CPED STAFF REPORT

CPC Agenda Item #5
September 15, 2014
BZZ-6715 and PL-285

Property Location: 501, 507, 515 and 523 8th St. S., 502 and 518 9th St. S., and 811 5th Ave. S.
Project Name: Kraus Anderson Corporate Headquarters
Prepared By: [Becca Farrar-Hughes](#), Senior City Planner, (612) 673-3594
Applicant: Kraus Anderson, (612) 332-7281
Project Contact: Pope Architects, (651) 642-9200
Request: To construct a 4-story office building and associated underground and surface parking on a full city block in Downtown.

NORTH ELEVATION

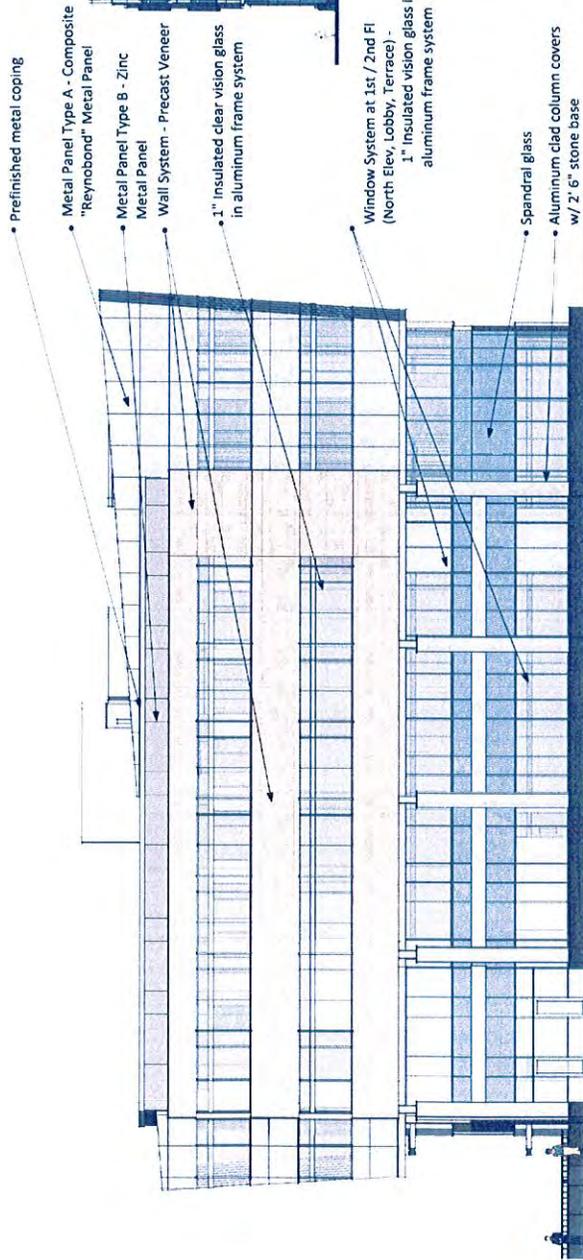
- The building complies with the window provisions with the exception of the south elevation of the building facing 9th Street South. Alternative compliance is necessary. Given all of the application requests and the fact that no phased development is planned for the remainder of the block, the development as proposed is not supported by Staff and as such Staff would recommend that alternative compliance not be granted. In addition, the windows on the ground floor of the west and south elevations the windows are not even distributed. More than half of the west elevation of the building directly abutting the public sidewalk along 5th Avenue South has spandrel glass windows. All windows are vertical in proportion. Alternative compliance is necessary. Staff would recommend that alternative compliance not be granted for window distribution. See **Table I**.

- **Window requirements - % and even distribution.** The building complies with the window provisions with the exception of the south elevation of the building facing 9th Street South. Alternative compliance is necessary. Given all of the application requests and the fact that no phased development is planned for the remainder of the block, the development as proposed is not supported by Staff and as such Staff would recommend that alternative compliance not be granted. In addition, the windows on the ground floor of the west and south elevations the windows are not even distributed. More than half of the west elevation of the building directly abutting the public sidewalk along 5th Avenue South has spandrel glass windows. All windows are vertical in proportion. Alternative compliance is necessary. Staff would recommend that alternative compliance not be granted for window distribution. See Table I.

GRADING PLAN

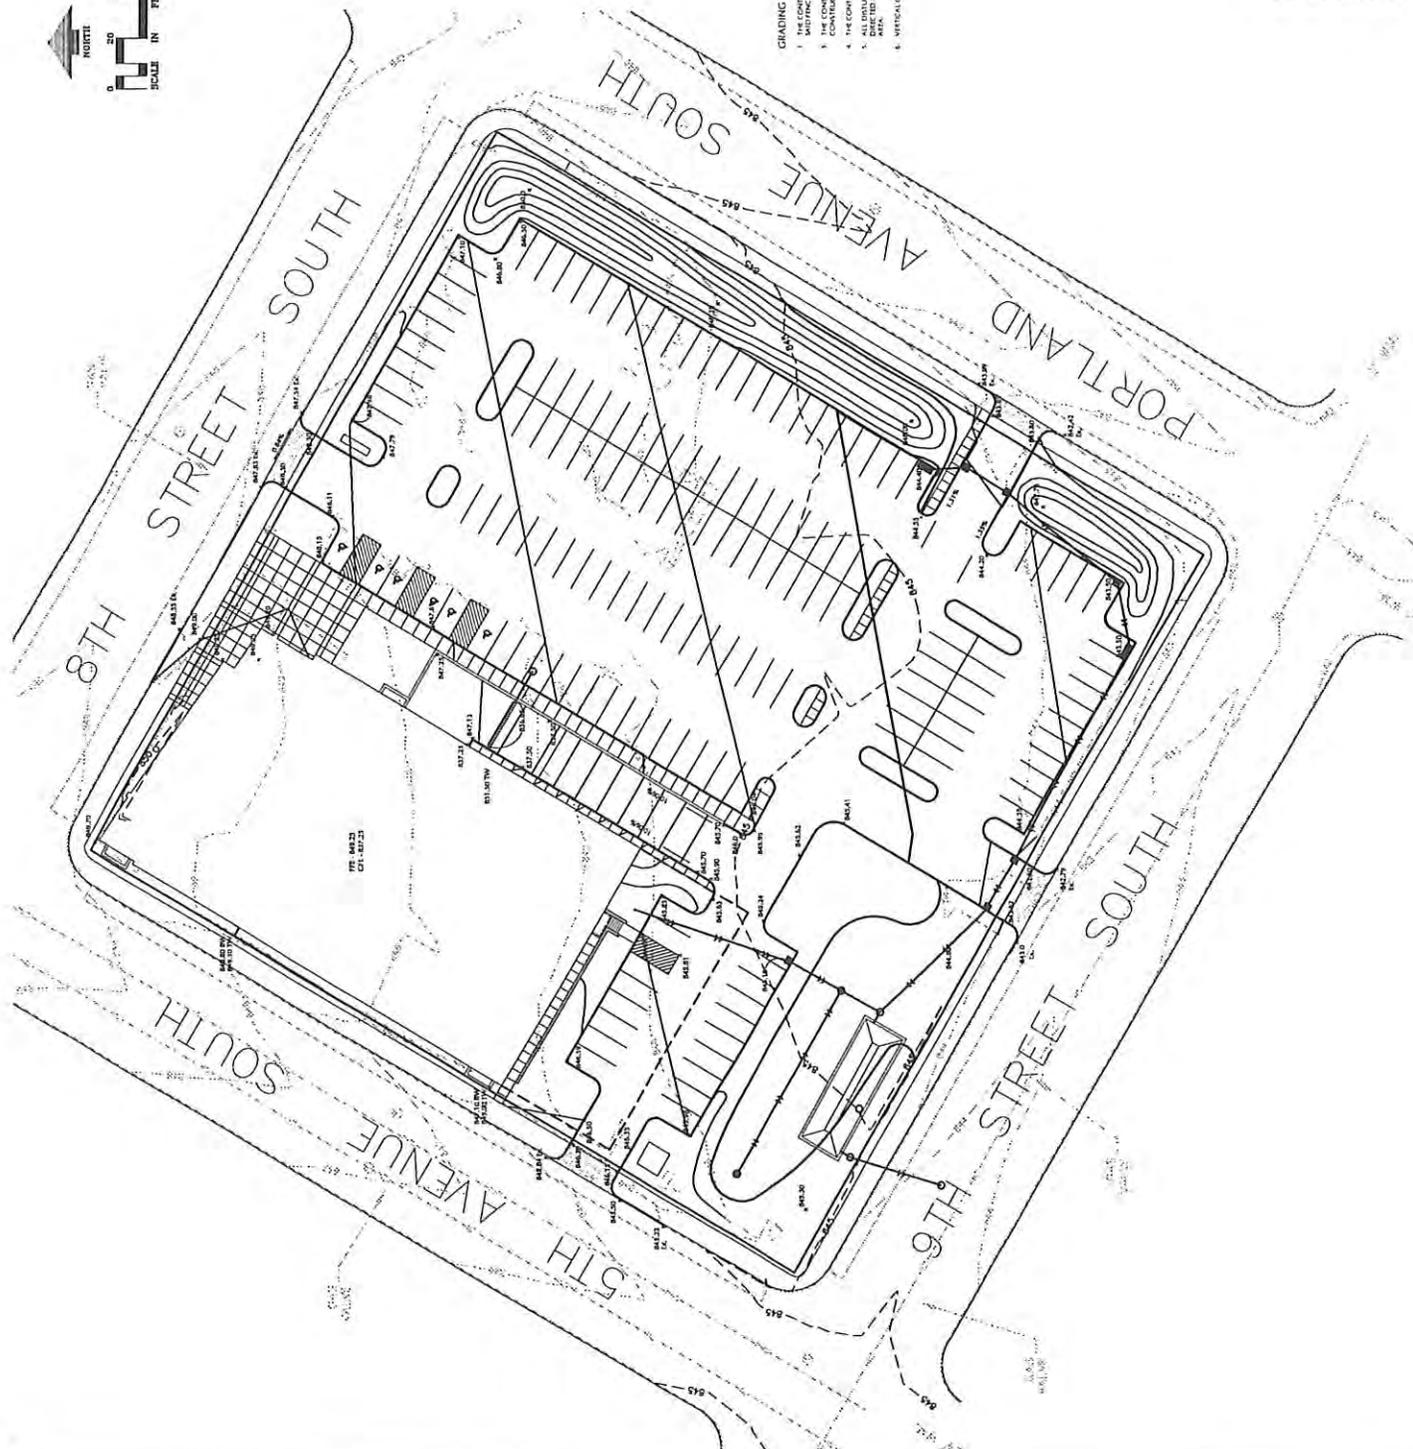
- Please provide a detail of the underground infiltration system. The detail should verify the volumes of the modeled system (top, bottom and side rock widths, layout, etc.). Currently the dimensions in the model differ from those on the plans. The elevations also differ.
- The Storm Data File and Air Temp File in the P8 model should be those appropriate for Minneapolis, not the default P8 files. A 1.25" event should be used for the water quality modeling. Please note the Loops Thru Storm File should be a minimum of 5 when modeling a single event.
- An operations and maintenance plan is required for the stormwater treatment devices. The O&M plan shall define the maintenance regimen, including type and interval of maintenance and party to conduct such maintenance. Please provide a copy of the O&M Plan.

- The proposed storm sewer service connection to the City main should be core-drilled and a saddle tee fitting installed, per City of Minneapolis Standard Supplemental Specifications. A new manhole is not permitted for the connection. Please revise the plans accordingly.

Image of rooftop mechanical unit

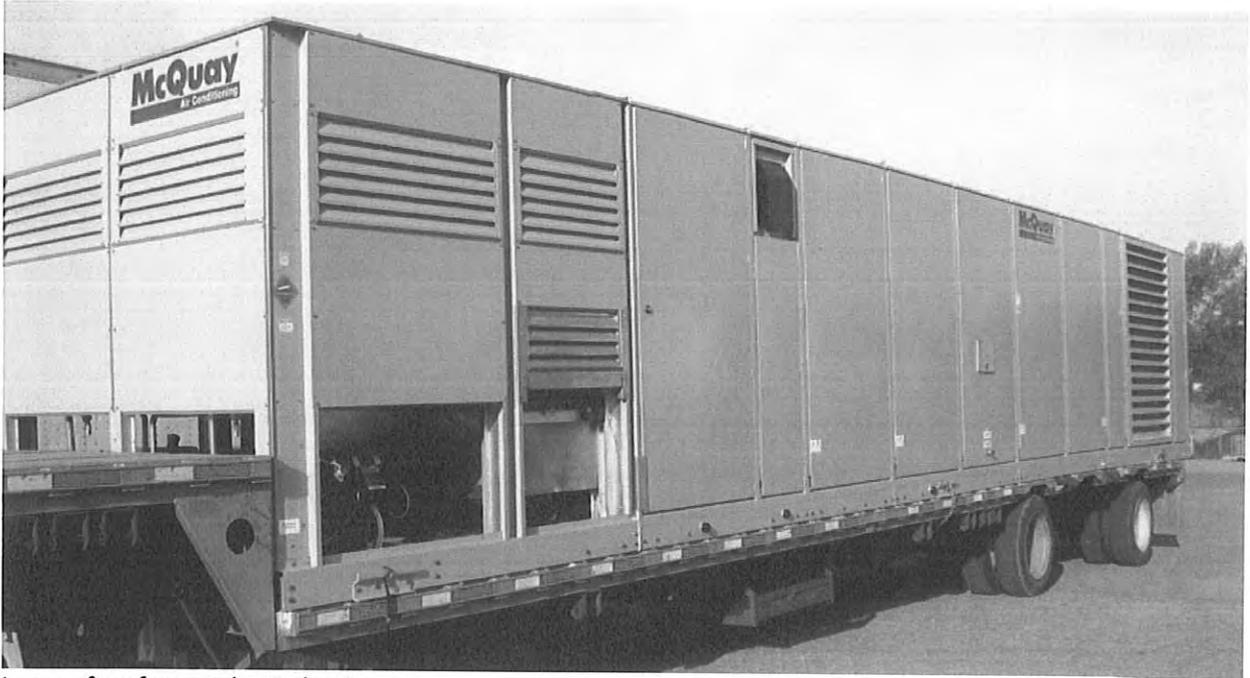
- e. **Mechanical screening for rooftop units:** Allowing two large mechanical units with dimensions that are similar to a large school bus at a total of 11 feet in height (8 foot tall units on a 3 foot curb) and 40 feet in length on top of roof in Downtown Minneapolis with no screening is unreasonable and would not be in keeping with the spirit and intent of the ordinance and the comprehensive plan. Given the minimal height of the proposed structure, the large mechanical units will be visible from taller buildings as well as from various vantage points on the public street. The precedent of allowing unscreened rooftop mechanical units is unacceptable regardless of whether it is in a downtown setting or in a location outside of downtown.
